MEMORANDUM

To: The Design Advisory Board
From: Mary O'Neil, AICP, Principal Planner
RE: ZP19-0284CA; 69 Charlotte Street
Date: October 9, 2018

File: ZP19-0284CA
Location: 69 Charlotte Street
Zone: RL **Ward:** 5S
Parking District: Neighborhood
Date application accepted: September 24, 2018
Applicant/ Owner: Selin & Selin Architects / Sa & Paul Budnitz
Request: Demolish and replace existing single family home and accessory structure.

SOUTH ELEVATION
SCALE $\frac{1}{8}" = 1'-0"$

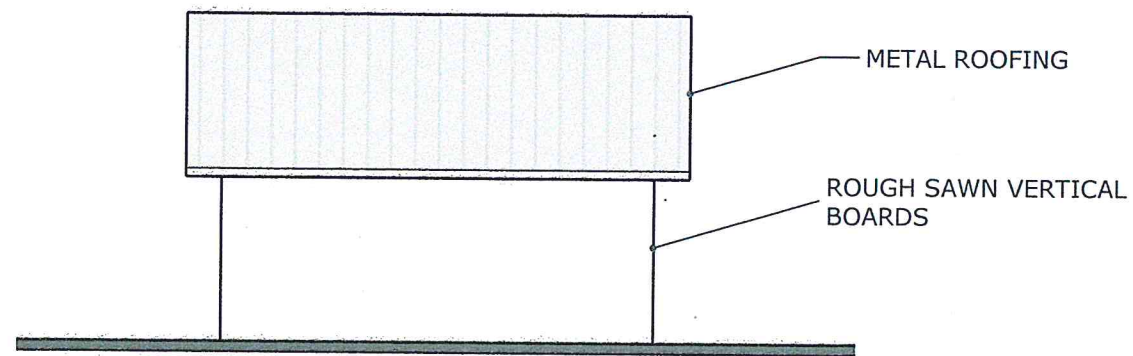
HVAC equipment is illustrated on the south elevation, observing the required setback. Screening may be appropriate due to the visibility of the unit from the public way. The location of the electric meter is on the north (side) elevation. Aerial electrical service will be maintained as the line comes from a pole across the street. The location of the mailbox has not been defined.

The proposed condensing unit shall meet required setbacks so as to avoid the introduction of nuisance noise and minimize any impact to neighboring properties.

1. The HVAC shall be screened from public view.
2. Utility connections shall be undergrounded if possible. The location of all meters and utility connections shall be provided on the site plan and building elevations as appropriate.
3. All new construction is required to meet the Guidelines for Energy Efficient Construction pursuant to the requirements of Article VI. Energy Conservation, Section 8 of the City of Burlington Code of Ordinances.
4. If trash and recycling are proposed for the open garage structure, it shall be secured and screened from public view.
5. Standard Permit Conditions 1-15.

FRONT DOOR
LIGHT FIXTURE.
BUDNITZ RESIDENCE

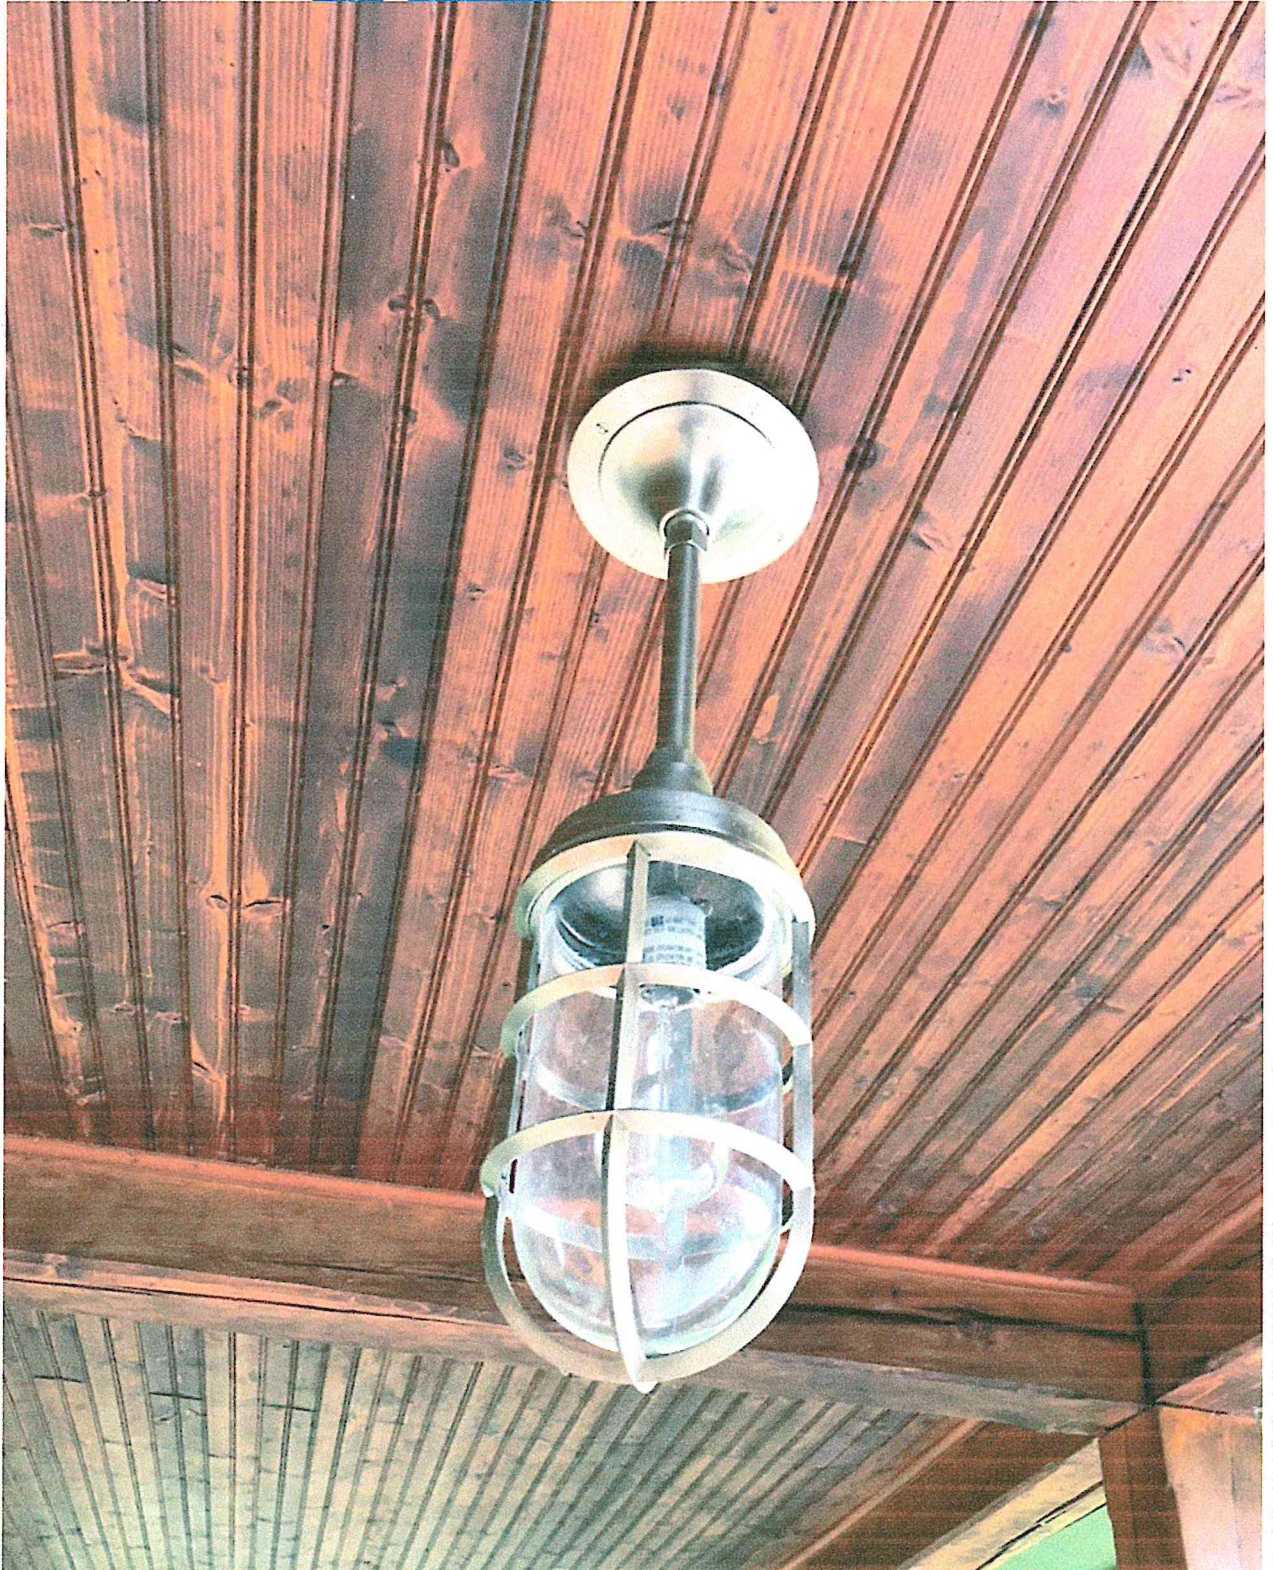
Modest residential scale lighting is proposed. See attached images.

1 PROPOSED SITE PLAN

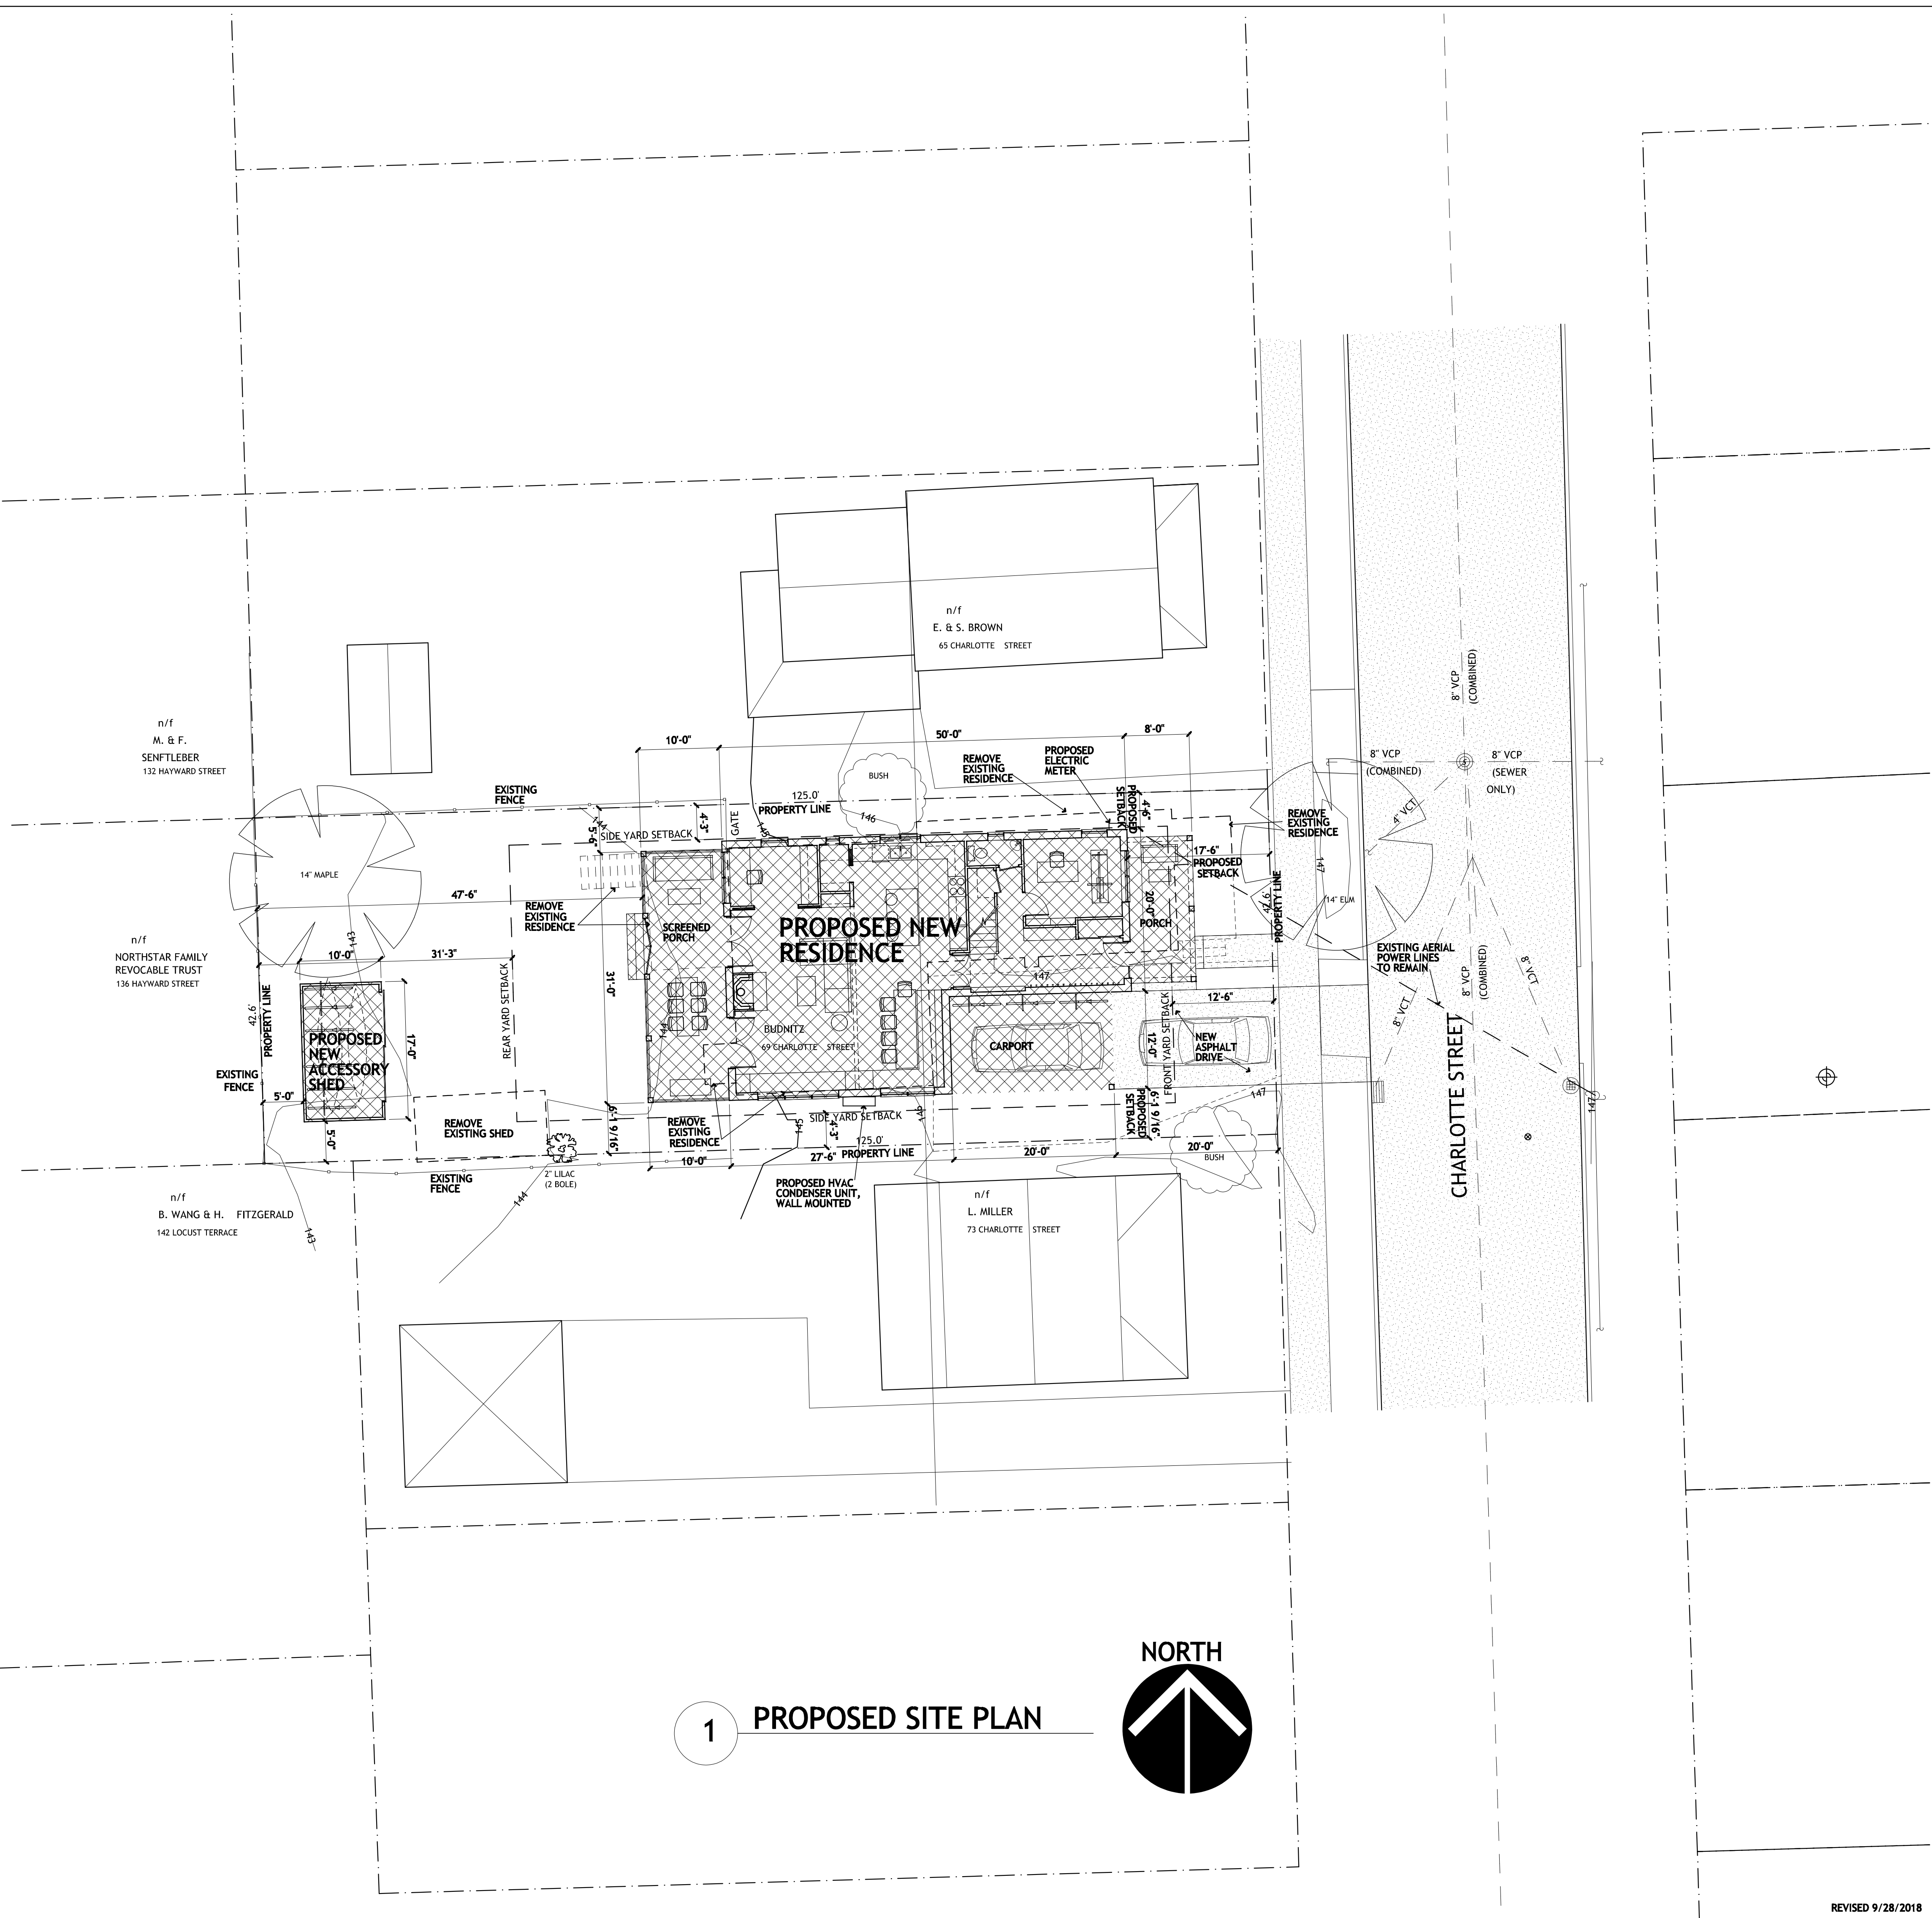
A front setback is required and observed. The garage is set back 20' from the front property line. While this standard requires a 25' setback for garage walls containing doors; this project has no garage doors and can still provide tandem parking. Placement is therefore acceptable.

The site plan provides for the two required parking spaces; one in the open garage and one in the driveway.

No landscaping plan has been provided. The relatively constrained site will retain a mature maple in the rear yard, and shrubs on the north and southeast of the lot. Some landscaping or screening is recommended for the HVAC unit.

Utility connections shall be undergrounded if feasible. Although not defined, it is assumed that trash and recycling will be located either in the open garage or the new accessory structure and therefore enclosed on all sides. If within the open garage, trash shall be secured and screened from view.
